SITE SURVEY DRAWING FOR SOIL ANALYSIS LOCATIONS

BARTHOLOMEW COUNTY HEALTH DEPARTMENT
440 THIRD STREET
COLUMBUS, IN 47201-6798
(812) 379-1550

SITE ASSESSMENT REPORT

TOWNSHIP: Ohio SECTION: 25 DATE: 4-14-97
SUBDIVISION: Parcel 2400 Site One LOT NO.:
FRONTING ON: West SIDE OF: SR 58 APPROXIMATELY: 3/4
(FEET-MILES): North OF: 700 S. (NEAREST CROSS ROADS)
ACRES: 22 DIMENSIONS:
PROPOSED ACRES: AND DIMENSIONS:
OWNER: Louis Joyner ADDRESS: 2824 Riverside Drive
REQUESTED BY: Louis Joyner PHONE: 372-0332 Work
MAILING ADDRESS: 2824 Riverside Drive, Columbus, IN 47201
SOIL(S): Cincinnati STRUCTURE: mod. subangblky TEXTURE: silty clay loam
LIMITING LAYER: fragipan 38-60" SLOPE: 2-15% LOADING RATE: .3

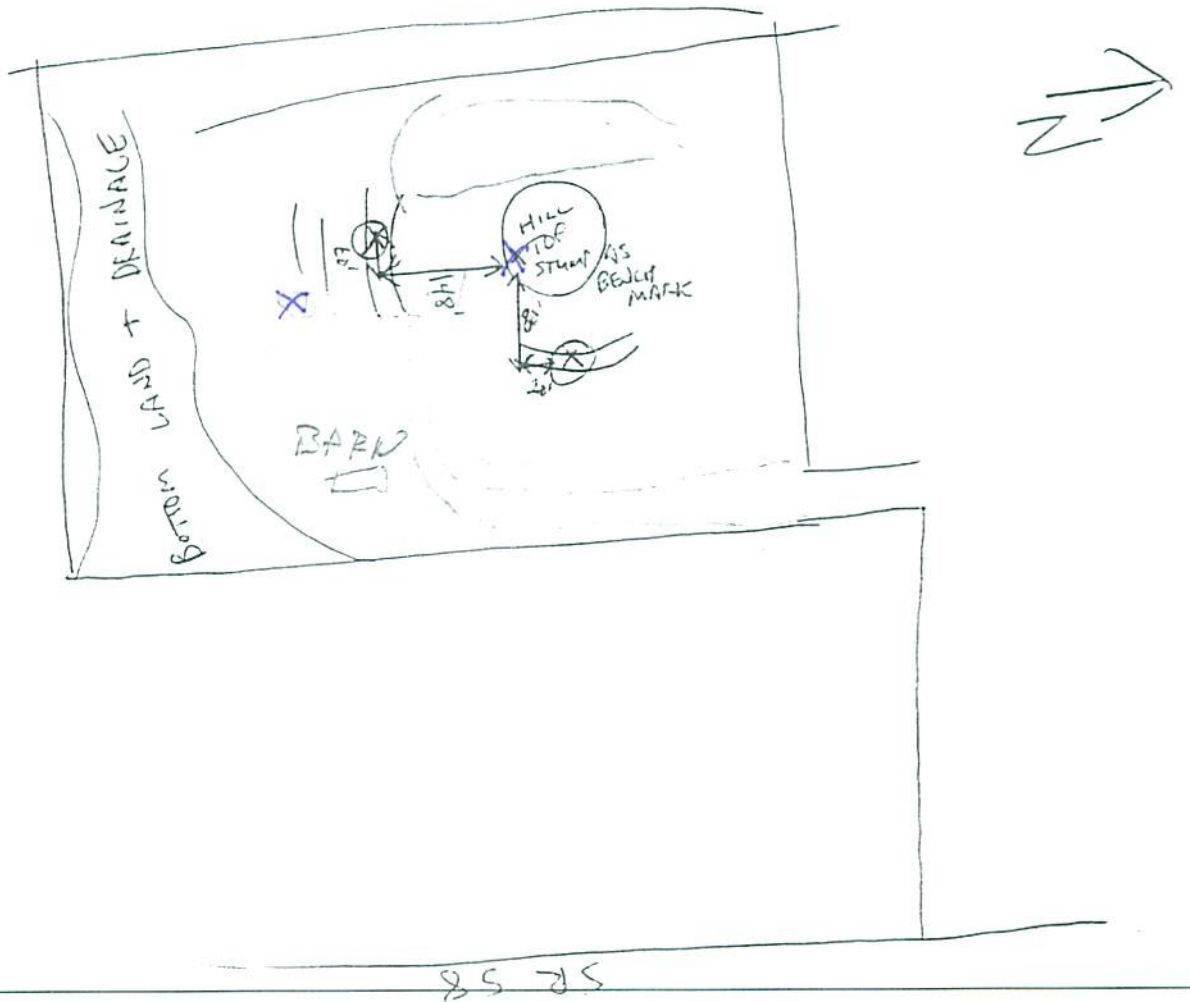
1. Install a septic tank with a gas tight riser sized according to the number of bedrooms in the home.
2. Install an appropriately sized pumping chamber for three or more bedrooms. Install pump sized to deliver daily design load at 30-60 gpm. Install an audible and visible alarm for the pump.

3. Install 500 square feet of subsurface absorption field per bedroom in trenches not to exceed 14 inches in depth. Addition fill to be applied to cover aggregate with 12 inches of soil. Maximum square footage possible must be verified on-site prior to issuance of construction permit.

4. Install a perimeter drain up slope and along side slope at a minimum depth of 40 inches located no closer than 10 feet from septic absorption field.

5. A diversion ditch is to be installed up slope with sufficient depth and fall to move surface water to the side and away from the septic field.
6. The septic field is to be located directly East of the home site at soil boring one. Any alteration of this area may render the site unsuitable.

SITE SURVEY DRAWING FOR SOIL ANALYSIS LOCATIONS

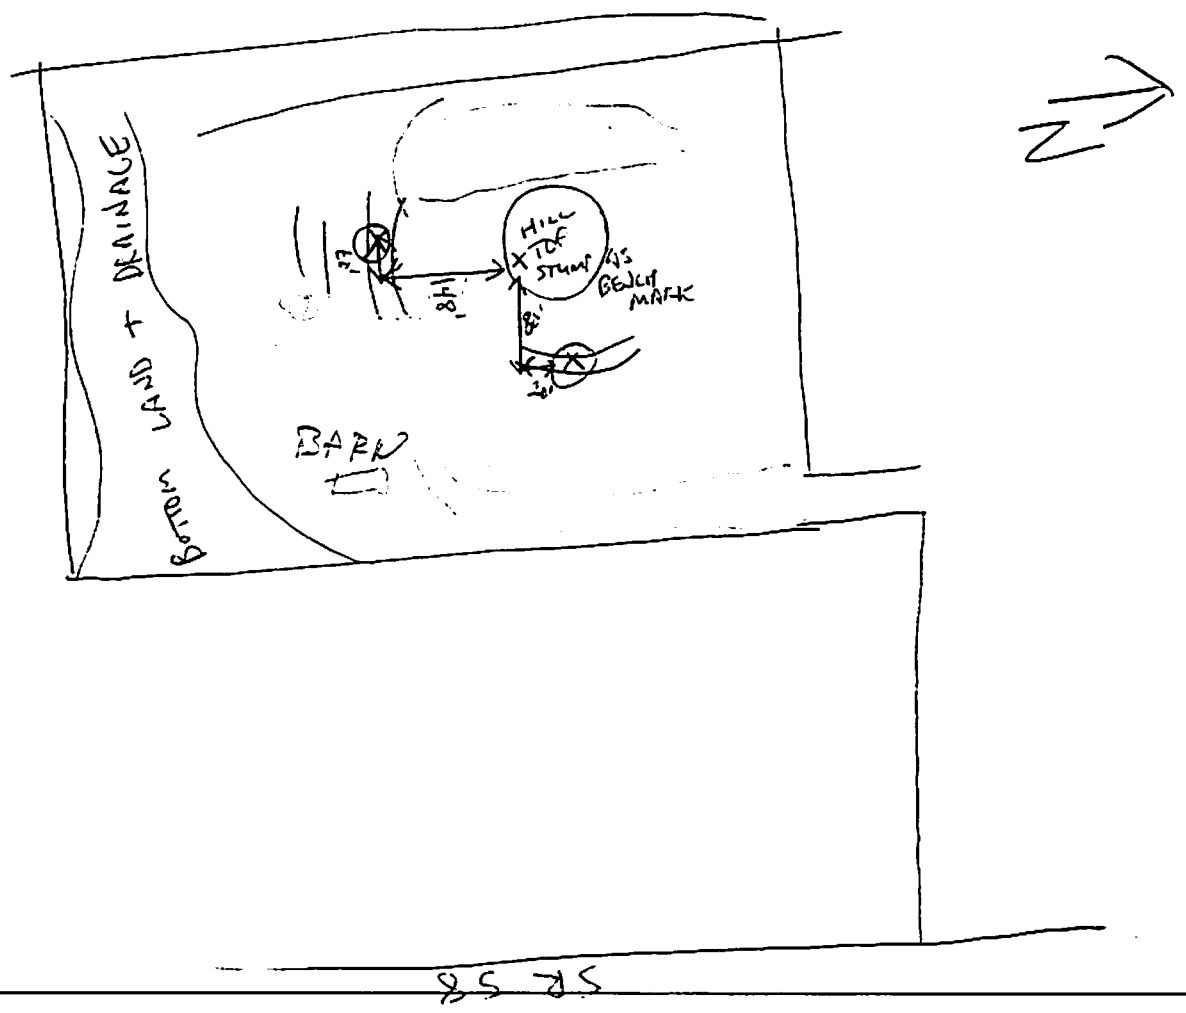
1. Install a septic tank with a gas tight riser sized according to the number of bedrooms in the home.
2. Install an appropriately sized pumping chamber for three or more bedrooms. Install pump sized to deliver daily design load at 30-60 gpm. Install an audible and visible alarm for the pump.

3. Install 500 square feet of subsurface absorption field per bedroom in trenches not to exceed 14 inches in depth. Addition fill to be applied to cover aggregate with 12 inches of soil. Maximum square footage possible must be verified on-site prior to issuance of construction permit.

4. Install a perimeter drain up slope and along side slope at a minimum depth of 40 inches located no closer than 10 feet from septic absorption field.

5. A diversion ditch is to be installed up slope with sufficient depth and fall to move surface water to the side and away from the septic field.
6. The septic field is to be located directly East of the home site at soil boring one. Any alteration of this area may render the site unsuitable.
